PS-Note, CULV BLOCK DIAGRAM

PROJECT : PS1 Quanta Computer Inc.			
Size Custom	Document Number <Doc> Penryn (HOST BUS) 1/3	Rev 1A	
Date: Saturday, October 31, 2009	Sheet 3 of 41

USB S5 CHARGER

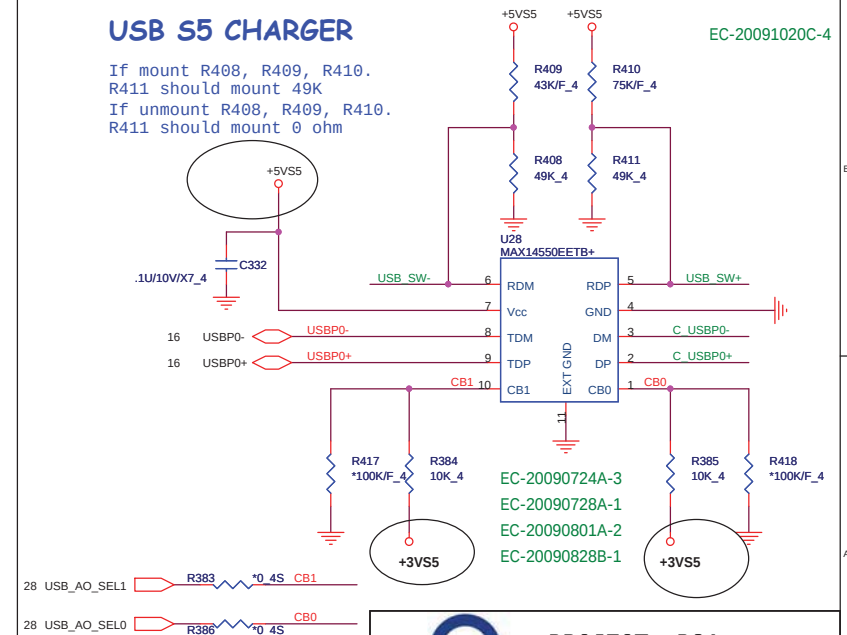
If mount R408, R409, R410.
R411 should mount 49K
If unmount R408, R409, R410.
R411 should mount 0 ohm

EC-20091020C-2	P24	Touch pad interface be changed from 13P(CN2) to 10P(CN22)
EC-20091020C-3	P31	Add PR164 to solve boot issue
EC-20091020C-4	P23	Remove R428 and R429, add R408, R409, R410 and R411 for USB charge circuit, the vendor suggest it for new chip application
EC-20091028C-1	P19	Adjust resistor value for Lan_LED light (R315 and R318 from 150 to 330)
	P20	Adjust resistor value for Logo_LED light (R414 from 510 to 1.8K)
EC-20091028C-2	P23	Change USB connector to yellow color
EC-20091028C-3	P35	Change PR68 from thermal-resistor to 0ohm due to remove render standby

RFID EEPROM

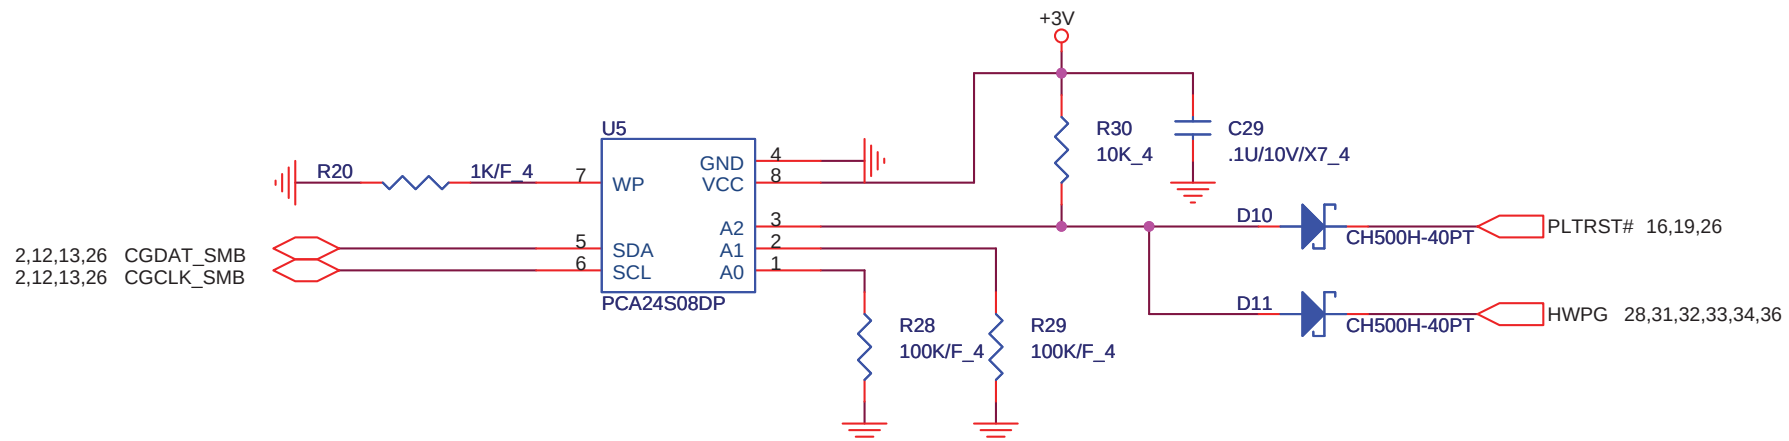
EC-20090804A-5

EC-20090804A-3	P22,25	ME RECOMMAND	CRT and SATA connector, change to correct footprint
EC-20090804A-4	P38		Add one Hole for M/B
EC-20090804A-5	P29	BIOS RECOMMAND	Add RFID EEPROM
EC-20090804A-6	P19		Modify LAN connector LED color
EC-20090804A-7	P27		Change one pin from GND to 5VSUS
EC-20090805A-1	P25	For layout space concern	Change SATA connector footprint to original U350 connector footprint
EC-20090805A-2	P38		Add one Hole for KB
EC-20090805A-3	P22		Stuff the Varistor for CRT
EC-20090806A-1	P23		Add EXT_GND for Thermal pad
EC-20090811A-1	P10	CRT ripple lesson learn	Change C165 from 0.1U to 4.7U for CRT ripple concern.

Size Custom	Document Number <Doc>	Rev 1A
POWER_Render (MAX8796GTJ+)		
Date:	Saturday, October 31, 2009	Sheet 37 of 41

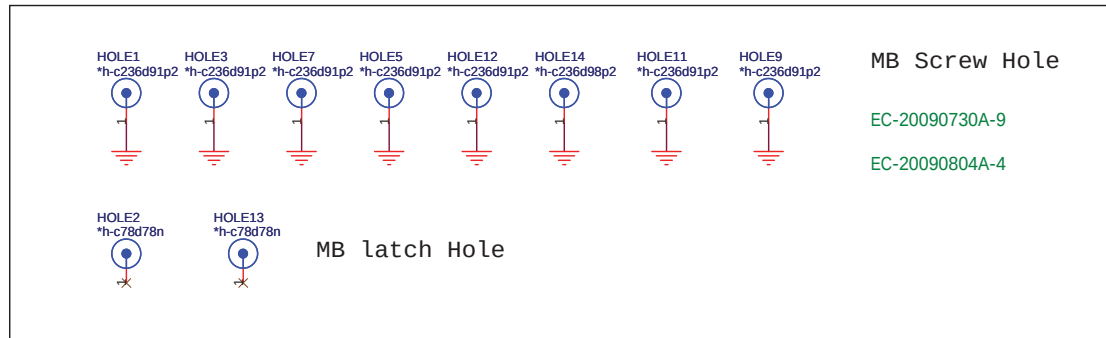
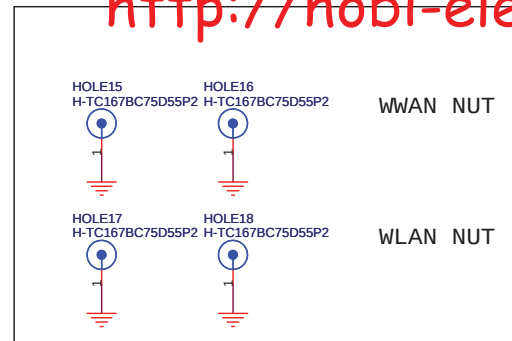
EC-20090726A-5

EC-20090824B-2

EC-20090726A-5

EC-20090813B-1

PS-Mika check with TIM about VCC_SENSE and VSS_SENSE

PS-Mika check with TIM

P16		Add WWAN PCI-E signal
	P26		Mini-PCIE connector interface change from SATA-IF to WWAN-IF
EC-20090726A-5	P7		Connect VID and Enable pin between NB and MAX8796
	P9		Reserve Render standby power for NB
	P37		Connect VID and Enable pin between NB and MAX8796
EC-20090727A-1	P23		Add ESD protection at USB Port
	P26		Add ESD protection at SIM-Card
EC-20090727A-2	P25		Reserve 0ohm on SATA Pin-18 for Gen1 or Gen2
EC-20090728A-1	P23		Modify USB charge circuit, CB0 and CB1 pull high with 5VPCU
	P23		R445 and R447 change to stuff
EC-20090728A-2	P18		All AGND net-name change to GND, But keep original symbol
EC-20090728A-3	P38		Add NUT for SB Thermal module used
EC-20090729A-1	P23		Connect USB_ON# control pin, to enable USB Power switch
	P28		Connect USB_ON# control pin, to enable USB Power switch
EC-20090729A-2	P14		Change Y4 footprint for accurate component
EC-20090729A-3	P16	SW RECOMMAND	Swap USB port by SW suggestion

EC-20090801A-6	P35	Change +3VSS supply MOS	Correct +3VSS output rating.
EC-20090801A-7	P34	Capacitor footprint change	Change PC121 and PC122 footprint from 7343-size to 3528-size
EC-20090801A-8	P23	Change USB net name	Change USBP13+_C and USBP13+_C net name to R_USB4- and R_USB4+
EC-20090802A-1	P27	EMI RECOMMAND	Reserve 0-ohm resistor for USB signal (USB1, USB6, USB8)
EC-20090802A-2	P26	EMI RECOMMAND	Reserve 0-ohm resistor for CN12 GCLK_SMB_1 and GDAT_SMB_1 signal
EC-20090803A-1	P24	ESD RECOMMAND	Reserve VARISTOR for Touch pad signal
EC-20090803A-2	P37	Power Tim RECOMMAND	Pull high voltage change from 5VPCU to +3V for HWPG signal
EC-20090803A-3	P07	Intel Design Guide	Follow Intel Design Guide, Option A solution --> GFX_VR_EN Pull down 100K
EC-20090803A-4	P19		Change Transformer IO_GND to GND
EC-20090804A-1	P18		Remove L61 and L62, short the AGND and GND directly
EC-20090804A-2	P37	Power engineer RECOMMAND	Render standby be modified by TIM

EC-20090813B-1	P37	Remove PR76 and PU5.Pin12 connect to AGND directly
EC-20090819B-1	P10	C165 : Change footprint from 0402_Size to 0603_Size
EC-20090824B-1	P31	Remove PR35 to solve 3VPCU short to Gnd issue
EC-20090824B-2	P37	Remove PR81 to solve no +VCC_CORE issue, because the VRON levle is divided by 1/10
EC-20090824B-3	P36	PR220 change from 43K to 20K to solve no +1.5V_SS
EC-20090825B-1	P30-P34 and P37	PJP5, PJP13, PJP14, PJP15, PJP16 are removed and short directly PJP1, PJP2, PJP3, PJP4, PJP6, PJP7, PJP10, PJP11, PJP12 are changed to 0-ohm short-pad
EC-20090825B-2	P24	Add CN22 for 10-PIN Touch-Pad
EC-20090825B-3	P30, P32, P33, P34, P37	PR15, PR123, PR127, PR135, PR137, PR141, PR143, PR148, PR110, PR114, PR51, PR52, PR178, PR179, PR197, PR198 are changed to 0-ohm short-pad (0402-size) PR78, PR189, PR205 are changed to 0-ohm short-pad (0603-size)
	P20	R7, R232 are changed to 0-ohm short-pad (0603-size)
